Jepson Parkway Project
Final Environmental Impact Statement and Section 4(f) Evaluation

Volume II
Response to Comments

Solano County, California / District 4-SOL-O-STA / RPSTPL 6249 (004)

DRAFT REVISED PRELIMINARY

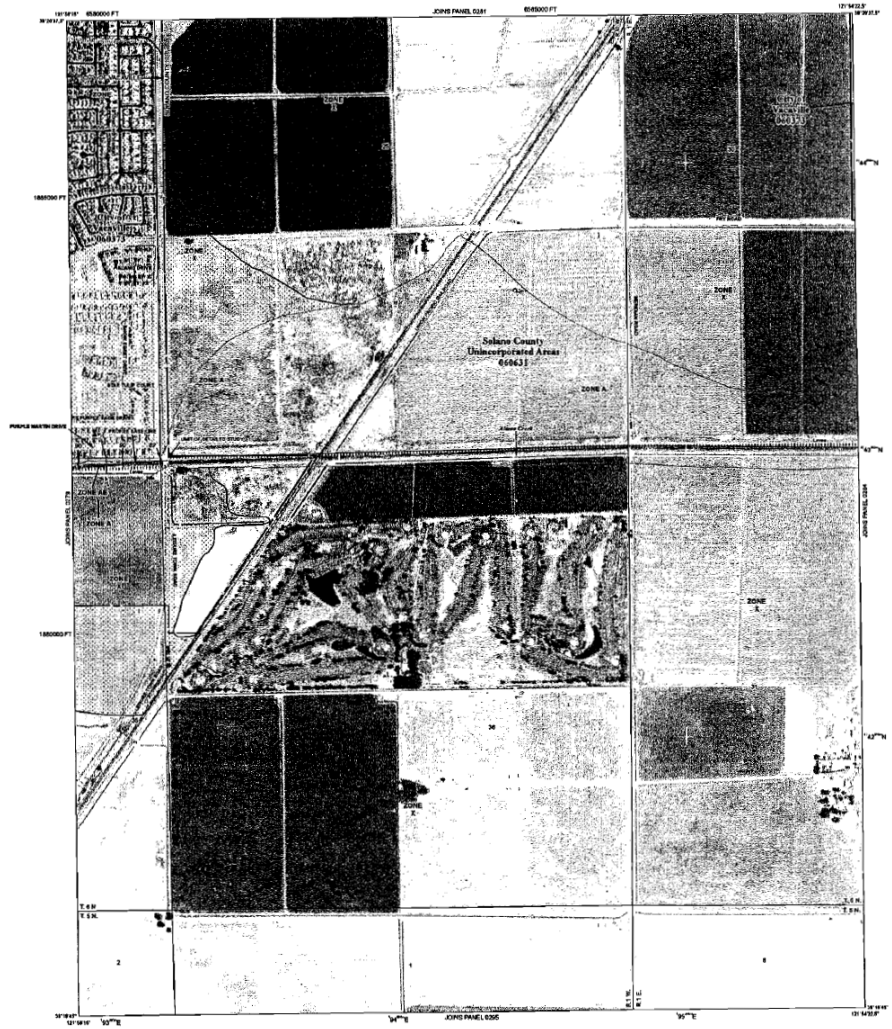
The Flood Insurance Rate Maps for Solano County are currently being revised. The Special Flood Hazard Area (SFHA) is anticipated to expand at the intersection of New Alamo Creek and Leisure Tow Road as shown on the attached preliminary panel, 06095C0283E. This expansion has the potential to impact your project as shown of Figure 3.9-3 of your report. 1-1

1-1. Thank you for the comment. The Special Flood Hazard Area for this area will be reviewed and accounted for during the final design phase of the project. A detailed hydraulic analysis of New Alamo Creek will be completed as part of the final design.
